Memorandum

To Stephen Fabling
Date 30 August 2022
Copies Tom Kennedy, Graeme Wood
Reference number 287249-00
From Sina Hassanli
File reference
Subject Impact of revised building envelope on expected wind conditions

In reference to the Arup environmental wind assessment report on Powerhouse Ultimo Renewal issued on May 4th, this memorandum is to provide a brief statement on the impact of the design changes in the building envelope on the pedestrian wind conditions in and around the site.

Figure 1. Revised building envelope

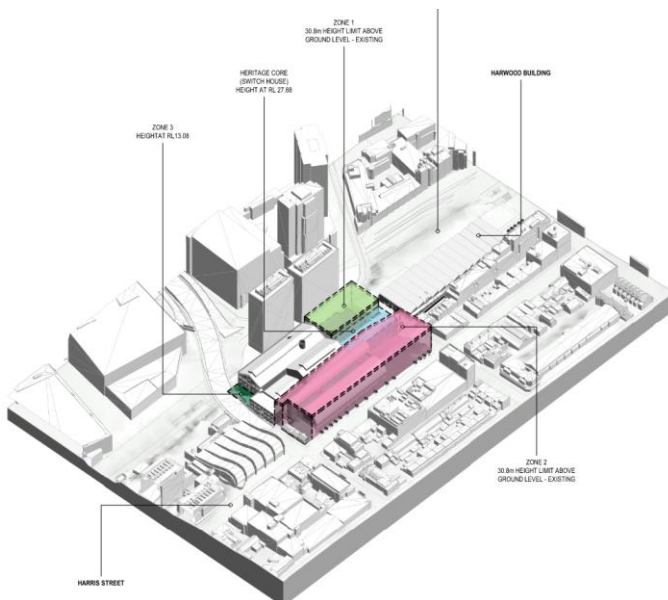
Removing the envelope to the northern Annex, boiler house, and turbine hall would not be expected to change the wind conditions around the site as the existing buildings occupy the same building footprint and height. Reducing the height of the Zone 3 envelope to the height of Pier Street as shown in Figure 1 would slightly improve wind conditions around the north-east corner as it would allow for the wind to go above the roof to expand and decelerate. Removing the envelope to the post office would result in wind conditions being similar to the existing conditions. Reducing the height of the envelope above the switch house (i.e. heritage core Figure 1) to apex of the existing roof would have a minimal impact since the surrounding envelopes (i.e. Zone 1 and 2 envelopes) are essentially taller.

In conclusion, the changes in the building envelopes are marginal from a wind perspective and the expected wind conditions in and around the site described in the Arup report issued on May 4th would remain valid.
